Sensor pads side

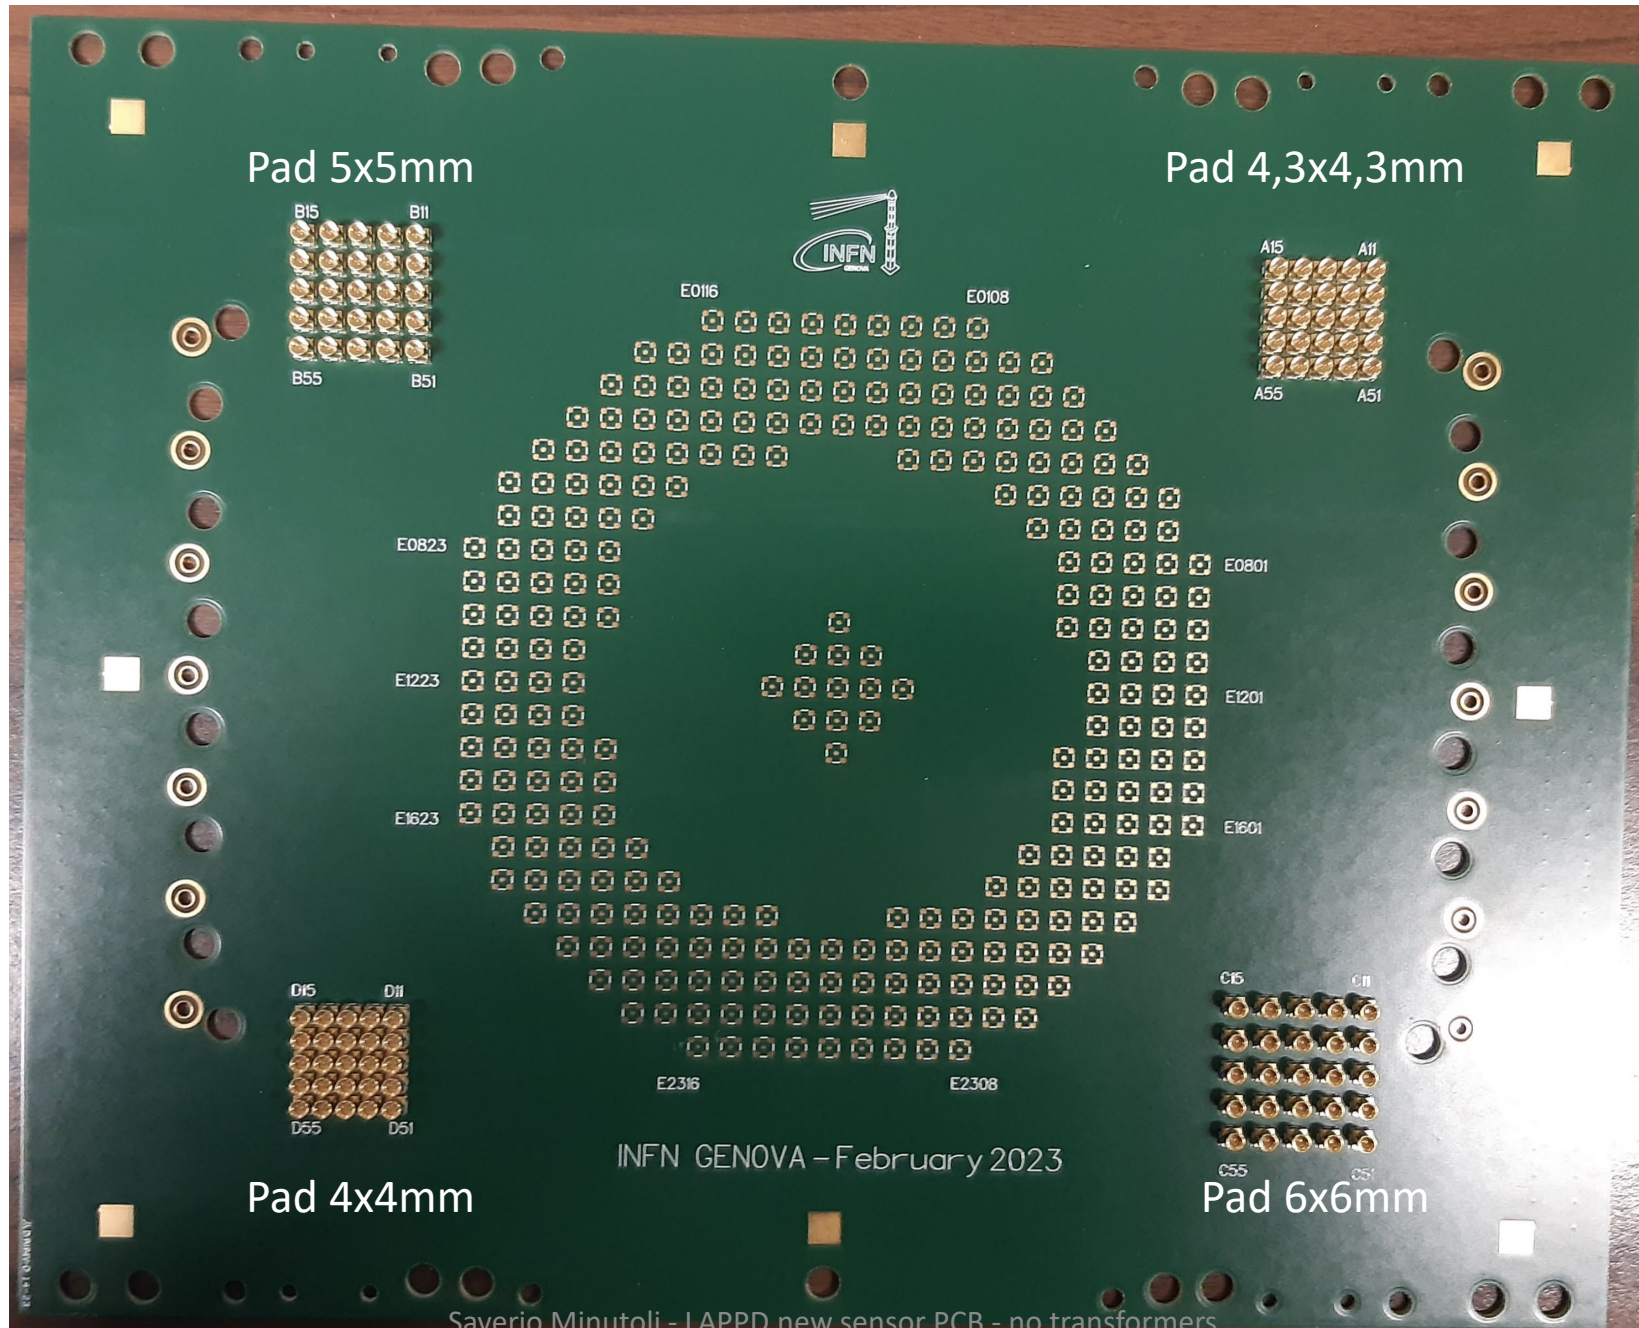
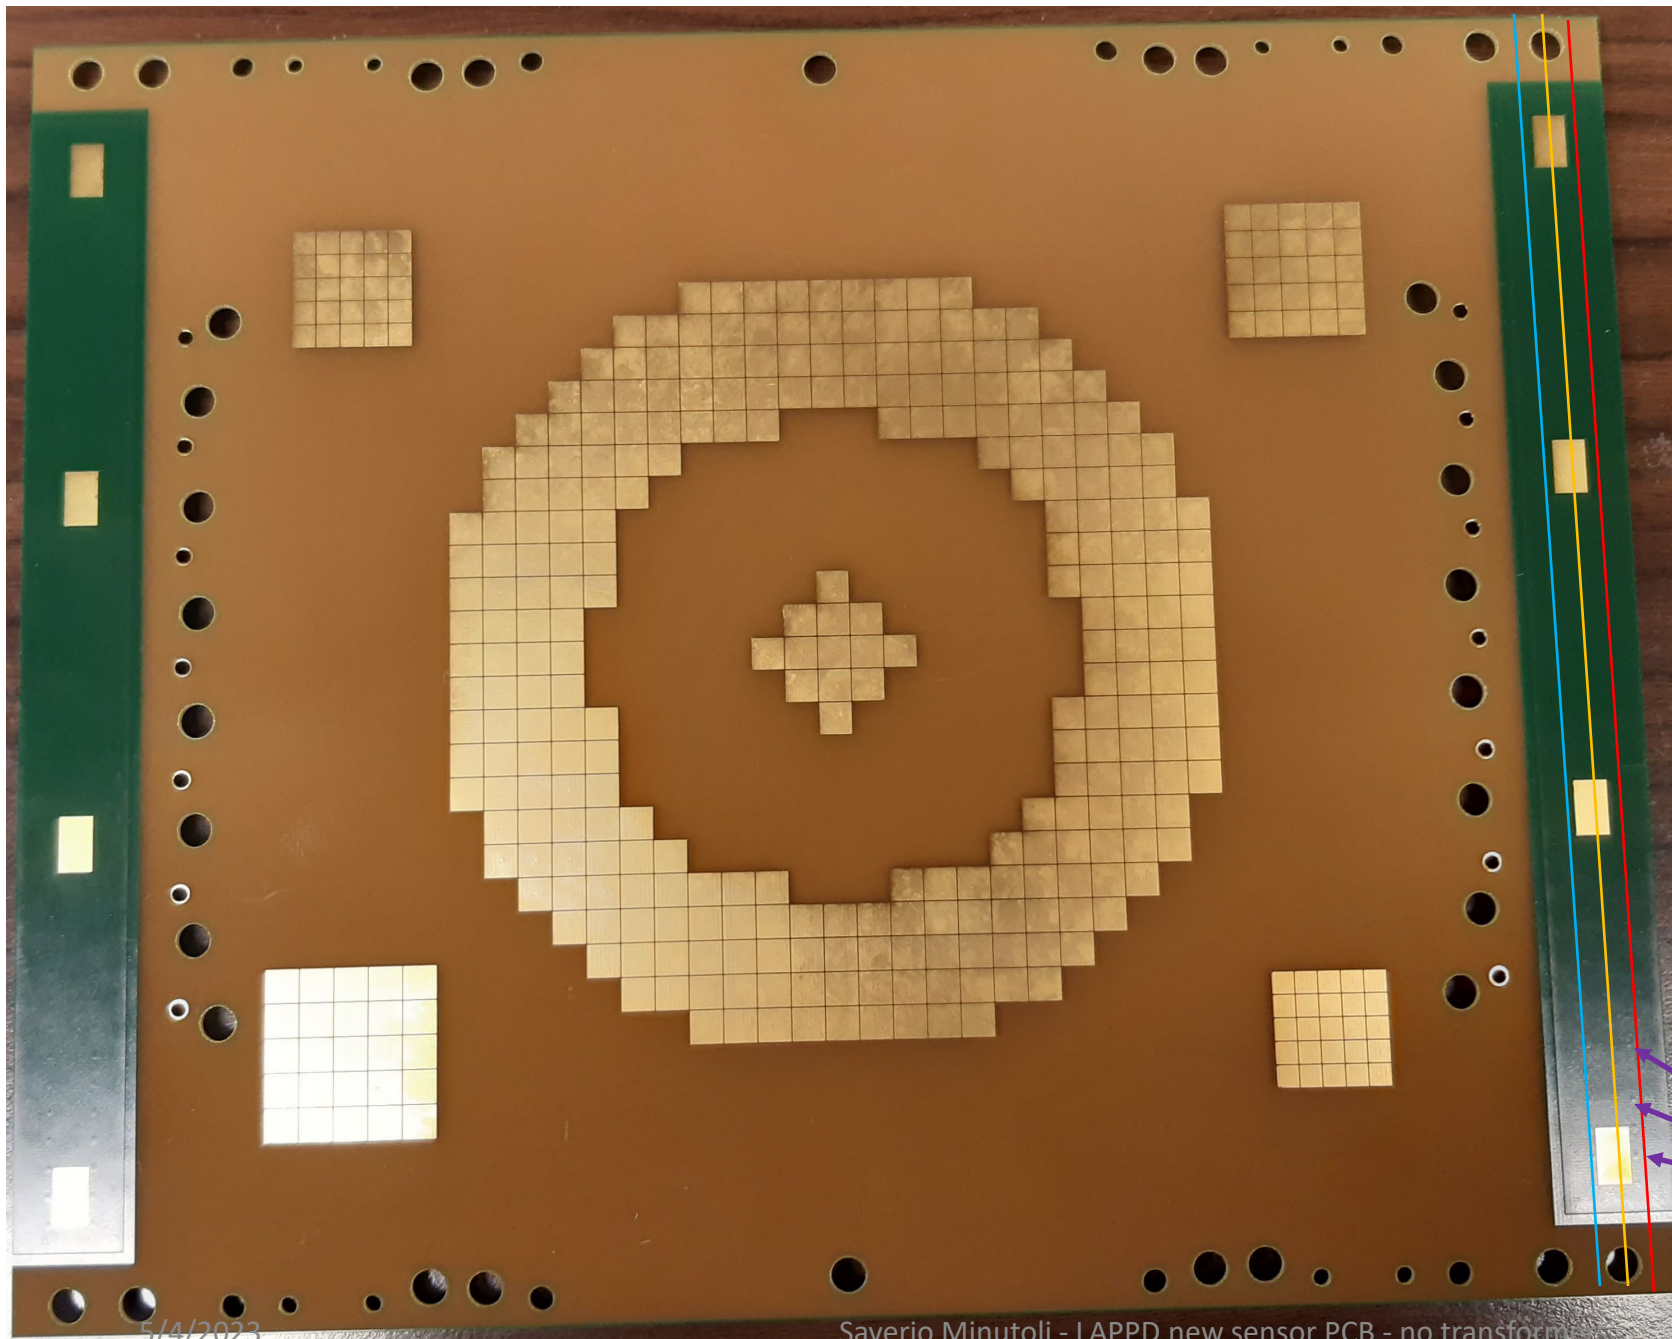
cutting distance from the edge

- 5mm
- 10mm
- 15mm

It would be better not to cut anything, but if you have to, we have 3 scenarios:

1. Red cut → does not imply anything
2. Orange cut → Reduces ground pads and eliminates a column of ground vias (see purple lines). It is still an acceptable solution.
3. Blue cut → Implies loss of ground pads. Critical solution, to be avoided.

**It is recommended not to exceed 10mm cut.**

Connector side

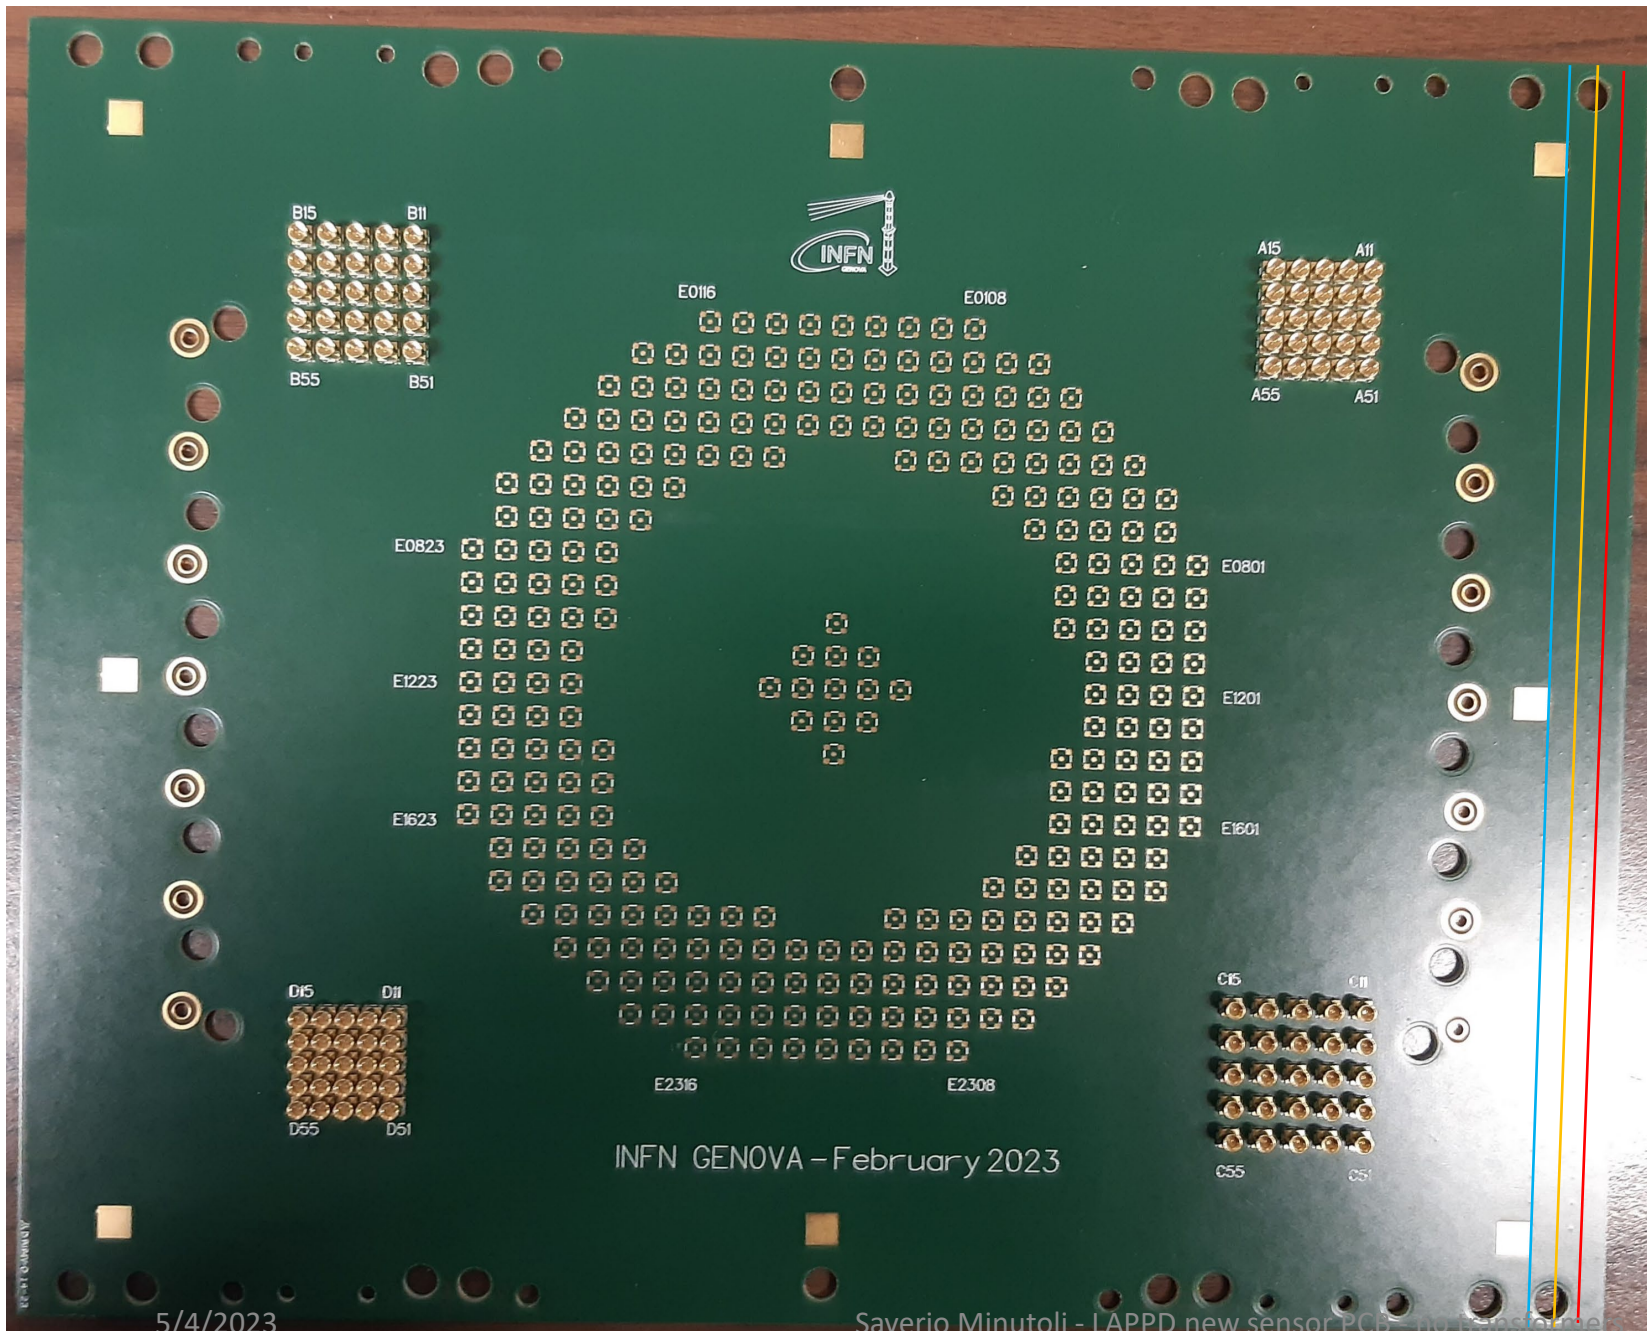
Ground vias

cutting distance from the edge

- 5mm
- 10mm
- 15mm

On this side there are no particular problems.

**However, given the considerations made for the sensor side, it is advisable not to exceed the 10mm cutting.**
